DEVELOPMENT REVIEW BOARD PANEL A AGENDA

2. [Resolution No. 422. ParkWorks Industrial Building and Partition.](#) The applicant is [requesting approval of a Stage I Preliminary Plan, Stage 2 Final Plan, Site Design Review, Type C Tree Removal Plan and Tentative Partition Plat for development of an industrial spec building with accessory office space and associated road and site improvements at 26600 SW Parkway Avenue.](#)

Exhibit A1
Staff Report
Wilsonville Planning Division
ParkWorks Industrial Building

Development Review Board Panel 'A' Quasi-Judicial Public Hearing
Revised March 4, 2024

NORTHWEST CORNER

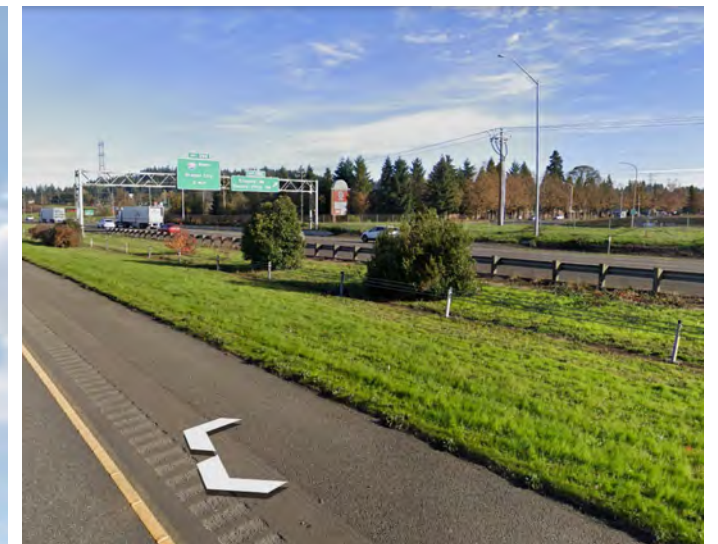
Prior to Non-Grading Building Permit Issuance: To meet the objectives and standards of Section 4.400(.01)-(.02) and 4.421 (.03) the applicant shall submit revised architectural elevations for the northwest corner of the property to include additional architectural treatments. Treatments shall include ~~the incorporation of materials used at the entrances of the building, or substantially similar,~~ for the purpose of façade articulation breaking up the massing of the building metal panels used at the entrances of the building (MP-1) applied in place of the areas painted Dark Marmalade (PT-7), breaking up the façade and uniform massing of that corner of the building.
